Item ID:	D350-607-543	Accept	*N900040100*	Setup	Start	*NS1*
Revision ID:					Stop	*NS2*
Item Name:	AS350/AS355 Quick Release Heli-Utility-Basket™ Long, Lightweight Lid					
Start Date:	6/5/2017	Start Qty:	1.00	*1*	Cust Item ID:	
Required Date:	6/12/2017	Req'd Qty:	1.00	*1*	Customer:	
Reference:	SCHEDULED/C					
Approvals:	Process Plan:	Date:	MAY 23 2017	Tooling:	Date:	
	QC:	Date:		SPC (Y/N):	Date:	
					Run	Start *NR1*
					Stop	*NR2*

DART SERVICE INSTRUCTION

**TO AMEND INSTALLATION INSTRUCTIONS D350-607-3 Rev.D,
INSTALLATION INSTRUCTIONS D350-607-4 Rev. C AND
INSTRUCTIONS FOR CONTINUED AIRWORTHINESS ICA-D350-607 REV. 6**

A	NEW ISSUE	AJS	14.05.16
REV.	DESCRIPTION	BY	DATE
DESIGN	AJS	DART AEROSPACE LTD HAWKESBURY, ONTARIO, CANADA	
DRAWN	AJS		
CHECKED	N/A	DRAWING NO.	REV. A
MFG. APPR.	N/A	DSI 9699	SHEET 1 OF 2
APPROVED		TITLE	SCALE
DE APPR.		LUG REPLACEMENT	NTS
DATE	14.05.16	COPYRIGHT © 2014 BY DART AEROSPACE LTD THIS DOCUMENT IS PRIVATE AND CONFIDENTIAL AND IS SUPPLIED ON THE EXPRESS CONDITION THAT IT IS NOT TO BE USED FOR ANY PURPOSE OR COPIED OR COMMUNICATED TO ANY OTHER PERSON WITHOUT WRITTEN PERMISSION FROM DART AEROSPACE LTD.

FIGURE 1: INSTALLATION OF D4775-041 FWD STRUT

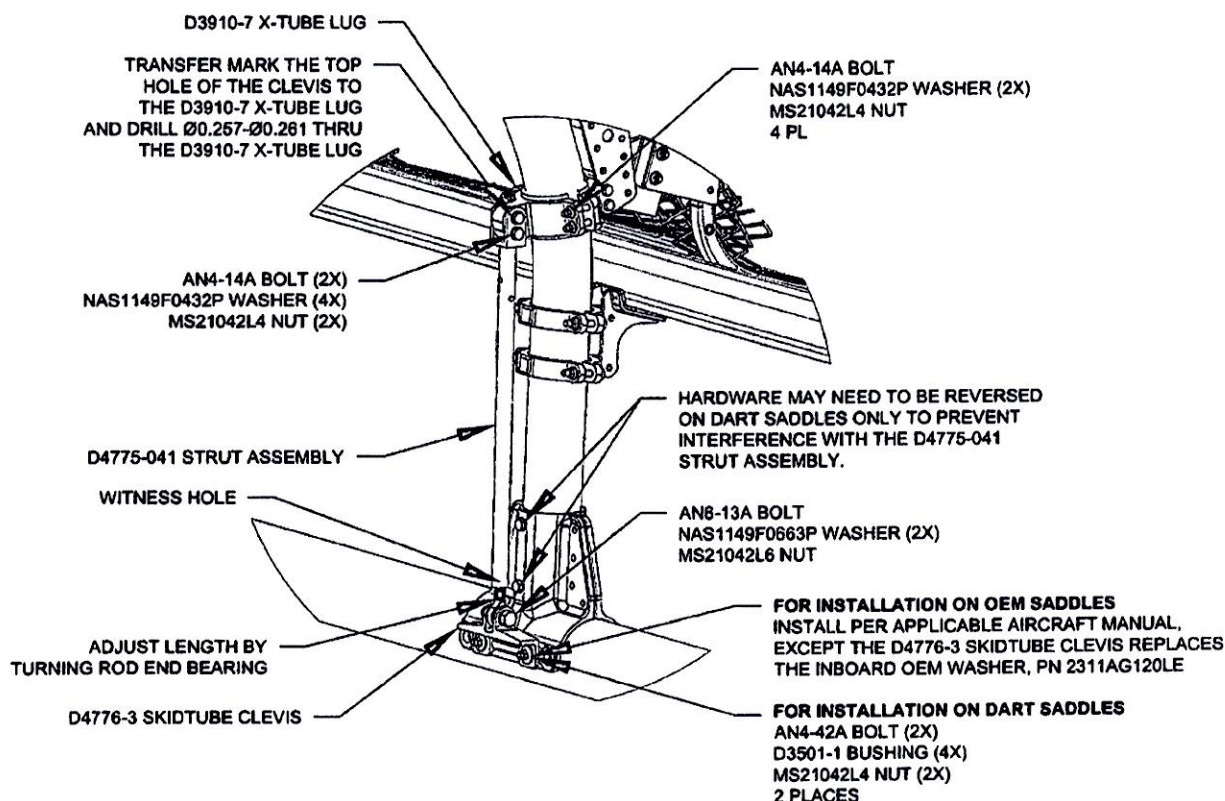
- 3.1 Substitute the Forward Lower D3910-5 X-Tube Lug with the D3910-7 X-Tube Lug as shown in Figure 1.
- 3.2 Install the forward D4775-041 Strut Assembly. Transfer mark from the upper hole on the clevis of the D4775-041 Strut Assembly to the D3910-7 X-tube Lug and drill thru the lug $\varnothing 0.257$ - $\varnothing 0.261$ as shown in Figure 1. Touch up chemical conversion coating per MIL-DTL-5541. Check the witness holes located at the bottom end of the D4775-041 Strut Assemblies to ensure that the thread from the rod end extends past the witness hole.
Torque MS21042L4/-4 nuts to 50-70 in-lbs (5.7-7.9 N-m). Torque MS21042L6/-6 nuts to 160-190 in-lbs (18.1-21.5 N-m).
- 3.3 Complete the installation in accordance with Installation Instructions D350-607-3 Rev. D or D350-607-4 Rev. C.
